Answer to referee comment 2 for “Airborne quantification of Angolan oil and gas methane emissions”

We would like to thank the reviewer for the detailed comments and suggestions to improve the manuscript. Below you find our answers to their comments. The reviewer’s comments are written in normal font, our answers in italics.

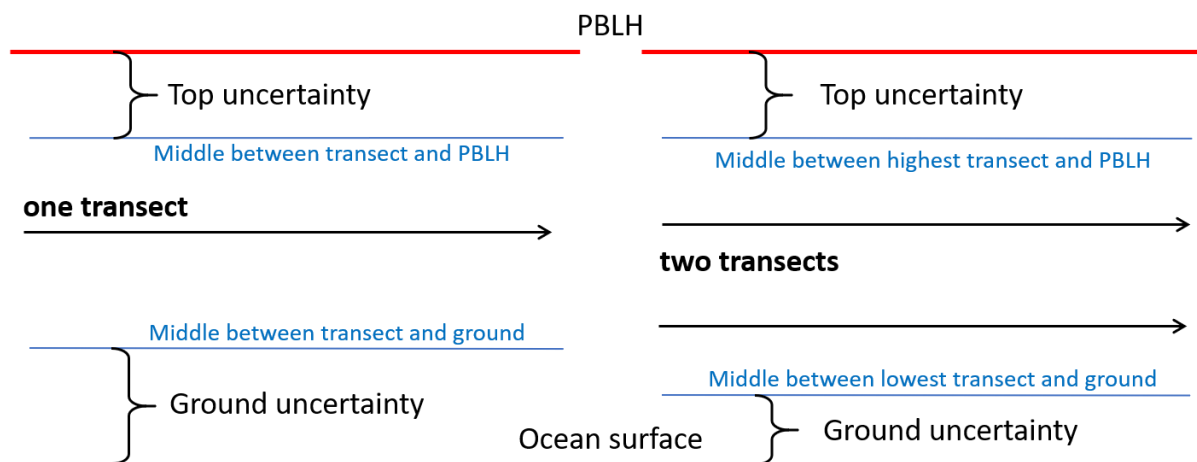
Line 578. How does the method create more flux uncertainty with fewer transect flown?

If there is only one transect, the plume height used for plume mixing height uncertainty is always half of the PBLH, separated into two parts: Ground uncertainty height from the ground to the middle between the ground and plume top uncertainty height from the middle between transect and PBLH up to the PBLH. If there are more than one transects, the two heights decrease because the distance between the individual transects is not considered uncertain. Please see the visual representation below.
